**Economic and Social Council**Distr.: General  
7 February 2020

**World Forum for Harmonization of Vehicle Regulations****Working Party on Lighting and Light-Signalling****Eighty-third session**

**Simplification of lighting and light-signalling UN Regulations:****UN Regulation No. 150 (Retro-Reflective Devices)****Proposal to correct the text of UN Regulation No. 150****Submitted by the Informal Working Group on Simplification of  
Lighting and Light-Signalling Regulations\***

The text reproduced below was prepared by the Informal Working Group on Simplification of Lighting and Light-Signalling Regulations (IWG SLR) with the aim to correct the Figures in Annex 24 to UN Regulation No. 150 and to improve the readability of the whole Annex.

Figure A24-II  
**Simplified marking examples for grouped, combined or reciprocally incorporated devices**

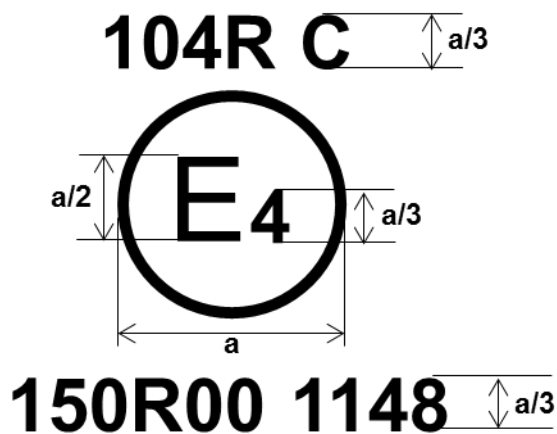
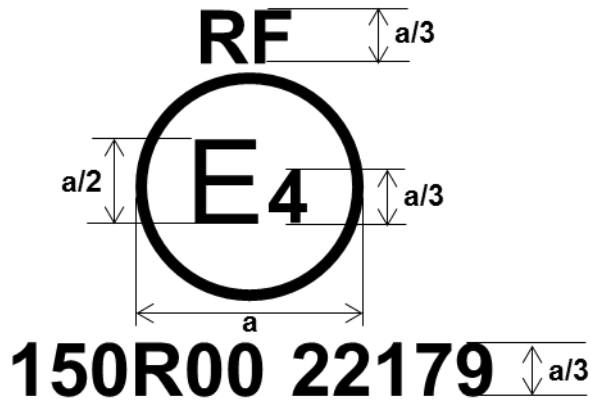
*Note:* The two examples of approval marks, models D and E, represent three possible variants of the marking of a lighting device when two or more lamps are part of the same unit of grouped, combined or reciprocally incorporated lamps.

1. This Annex has been editorially reorganized and streamlined without changing its contents.
2. The Figures have been corrected to provide examples of the approval marks using the new UN Regulations. For the size of “a”, the reference was corrected in order to refer to Table 1 instead of Table 2.

Figure A24-IV  
**Arrangement example of the approval mark for rear marking plates and SMV**

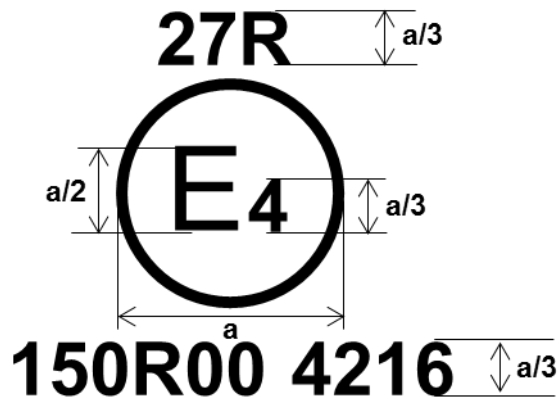
For a = see Table 1
